# Access Compliance Report

## Public Rights-of-Way

Intersection ID: 27280	Main Street: BACK_RIDGE_RD	Cross Street: ELMSTONE_DR	Location: NE
ADA ID: 521211F1C8F4	Ramp Type: PerpDiag	Initial Pass/Fail: Fail	Overall Compliance: No
Severity Score: 50			
Codes/Mitigation Info/Possible Solution		Field Measurements/Component Compliance

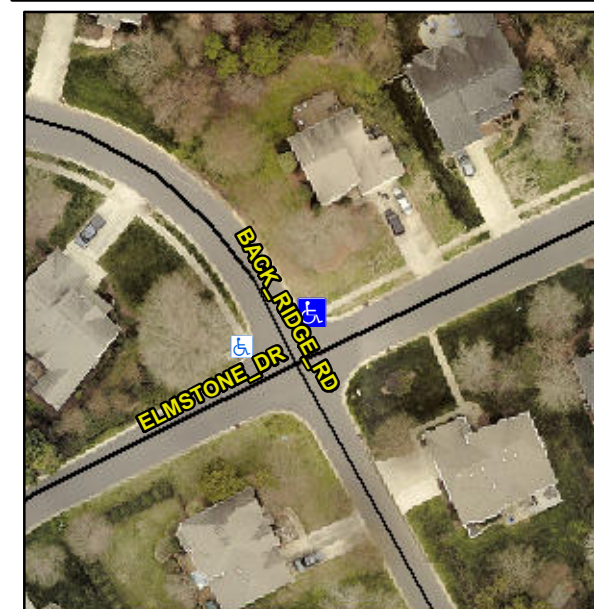
**Not Found, R304.2.2, R304.5.3**

Compliance	Description	Data	Compliance	Description	Data
N/A	Ramp Length (in)	35.0	No	Ramp Slope (%)	12.9
Yes	Ramp Width (in)	48.0	No	Ramp XSlope (%)	8.2
N/A	Flare Type LT	N/A	N/A	Flare Type RT	N/A
N/A	Flare Slope LT (%)	N/A	N/A	Flare Slope RT (%)	N/A
N/A	Flare Traversable LT?	N/A	N/A	Flare Traversable RT?	N/A
N/A	Landing Length (in)	N/A	N/A	DWS Provided?	N/A
N/A	Landing Width (in)	N/A	N/A	DWS Contrast?	N/A
N/A	Landing Slope (%)	N/A	N/A	DWS Length (in)	N/A
N/A	Landing X Slope (%)	N/A	N/A	DWS Full Width?	N/A
N/A	Landing Curb? (Y/N)	N/A	N/A	DWS Offset (in)	N/A
N/A	Shared Landing?	N/A			
N/A	Gutter Ponding?	N/A	N/A	Gutter Slope (%)	N/A
N/A	Gutter Lip Ht (in)	N/A	N/A	Gutter X Slope (%)	N/A
N/A	Painted X Walk1?	No	N/A	Painted X Walk2?	No
	X Walk 1 Direction	To W		X Walk 2 Direction	To SE
N/A	X Walk 1 Width (in)	N/A	N/A	X Walk 2 Width (in)	N/A
	X Walk 1 Slope (%)	3.7		X Walk 2 Slope (%)	5.9
	X Walk 1 X Slope (%)	3.7		X Walk 2 X Slope (%)	7.5

**Remove & Replace Curb Ramp With Two New Directional Ramps or Equivalent.**
